## **Appendix IV**

Consolidated Responses to Departmental and Public Comments Received in the Pre-submission Stage and the Previous Formal Submission Stage

## (a) Omission of above ground buildings within the "GB" zone and relocating them either underground or at "Recreation" ("REC") zone:

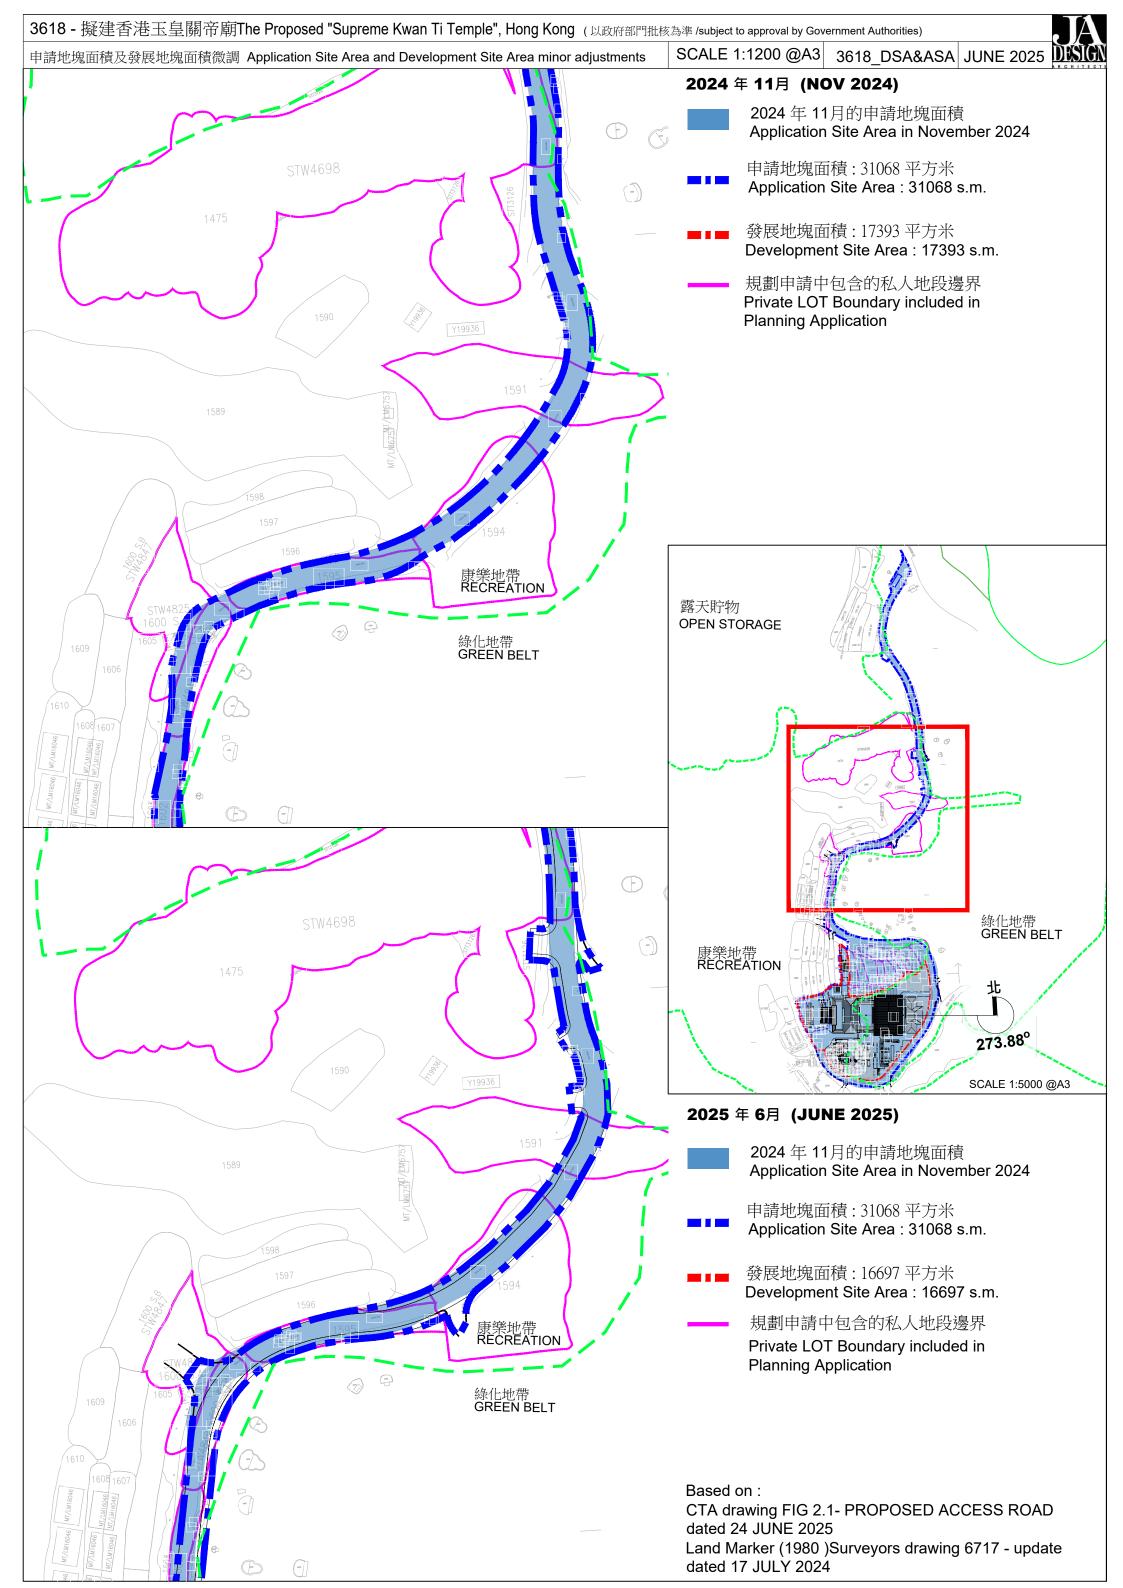
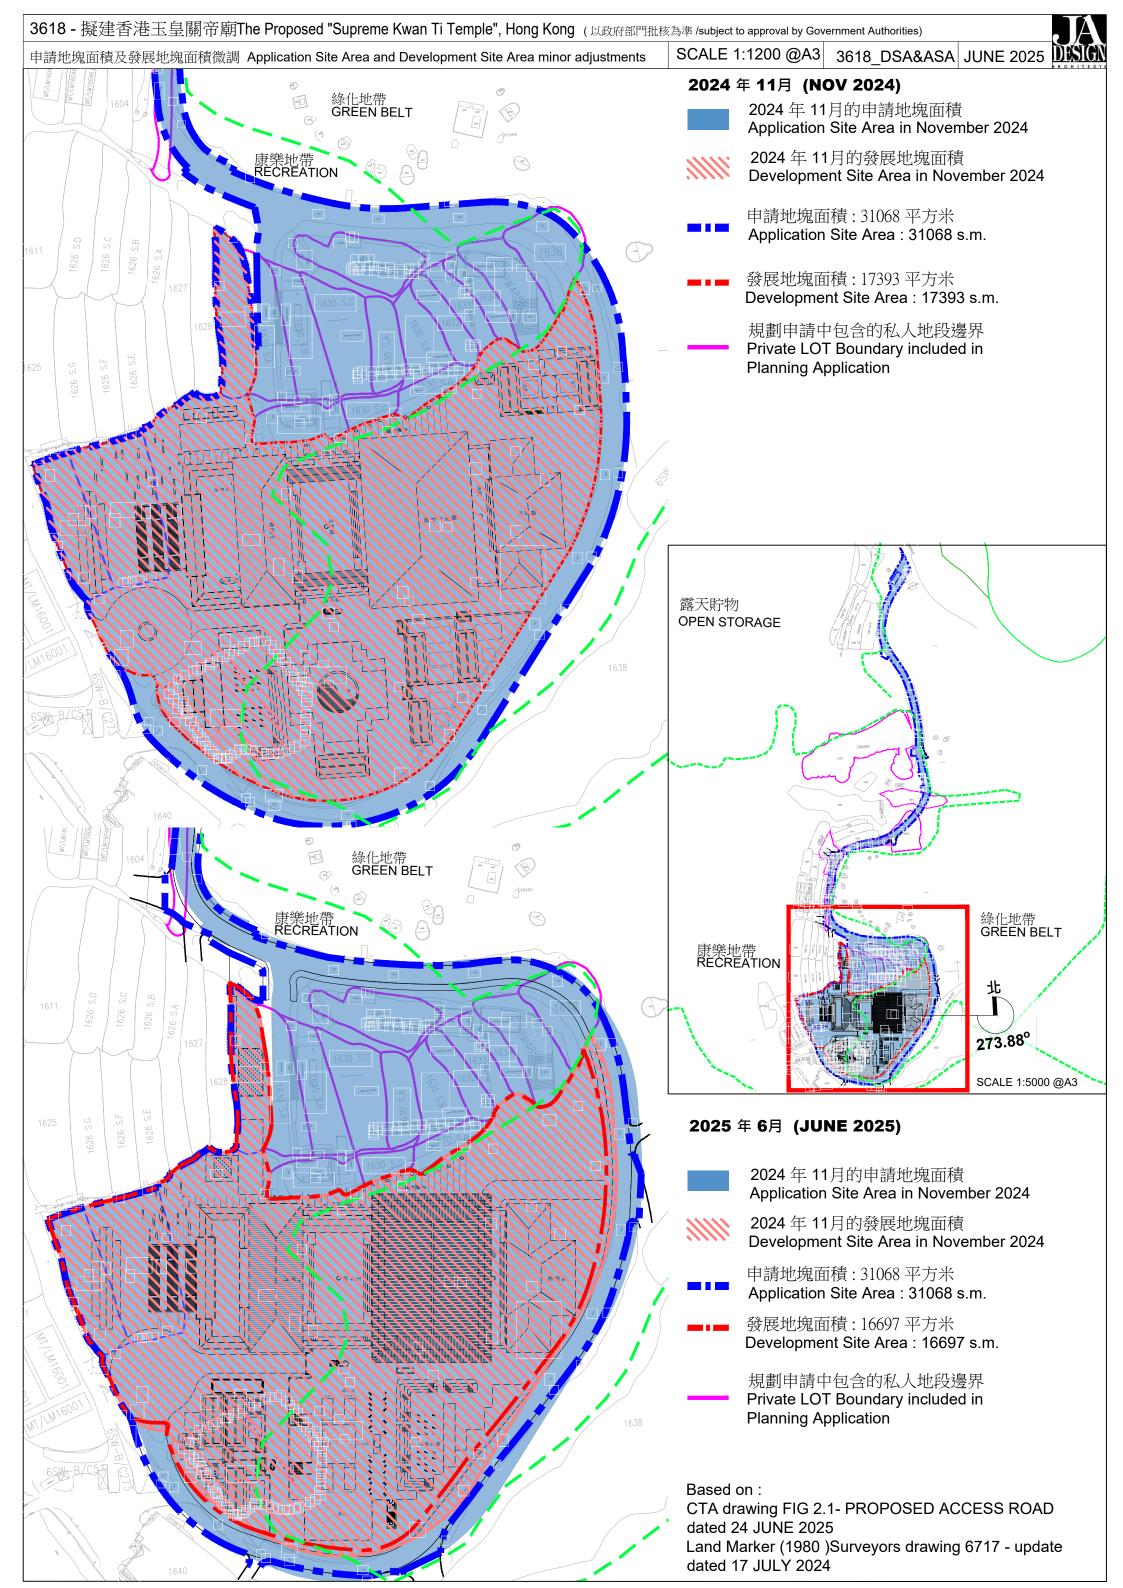
- The second and third floor of Hall of Manifestation has been relocated underground to first floor integrated with the exhibition space;
- The location of the Hall of Enlightenment and Swords Arena are interchanged, where Hall of Enlightenment has been relocated on "Recreation" ("REC") zone and Swords Arena with open space has been relocated at the "Green Belt" ("GB") zone. The building height of the Hall of Enlightenment has been reduced from 16.5m to 14m; and
- A Reception cum tea and exhibition at Lot 1629 has been introduced, which is within the "REC" zone.
